# HITACHI SEMICONDUCTOR TECHNICAL UPDATE

Classification of Production	MPU		No	TN-SH7-341B/E	Rev	2 <sup>nd</sup>
THEME	Usage notice in power supply of SH7751 and SH7751R		Classification of Information	1. Spec change 2. Supplement of Documents ③ 3. Limitation of Use 4. Change of Mask 5. Change of Production Line		
PRODUCT NAME	SH7751, SH7751R	Lot No.	Reference Documents	SH7751 series Hardware manual	Effective Date	
		ALL			Eternity

Figure 1. How to once set clock operation mode as mode 6.

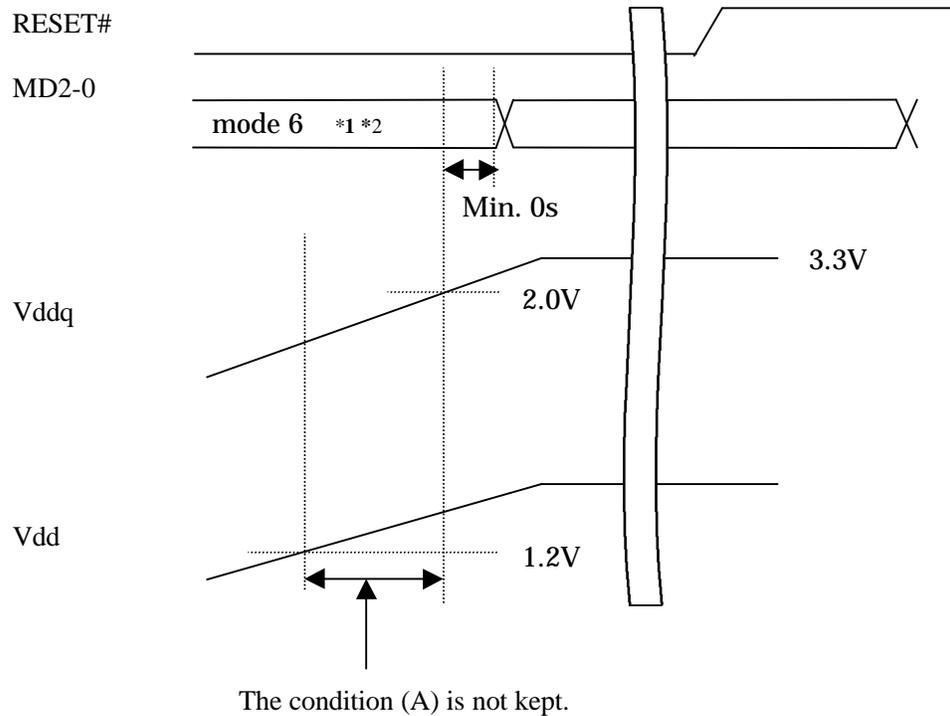
If the following condition (A) is not kept in supplying power, the clock may not be output correctly from the CKIO pin because PLL2 may oscillate abnormally.

When VDDs (VDD, VDD-PLL1/2) are higher than 1.2V, VDDQs (VDDQ, VDD-CPG, VDD-RTC) must be higher than 2.0V.

- (1) Set the clock operation mode 6<sup>\*1</sup> in supplying power, and secure the condition (A), then set desired clock operation mode (shown in Figure 1).
- (2) Once start in the clock operation mode 6<sup>\*1</sup>, then set desired frequencies by changing FRQCR  
(The clock divider 1 can't be used in this clock operation mode).
- (3) Once stop PLL2 (to write 0 to FRQCR.PLL2EN), and keep the FRQCR.PLL2EN as 0 for more than 1us, then restart PLL2 (to write 1 to FRQCR.PLL2EN). (It is not guaranteed that the CKIO output is stable until this operation is finished. If you use this workaround, please check the noise or the clock network on the real board.)
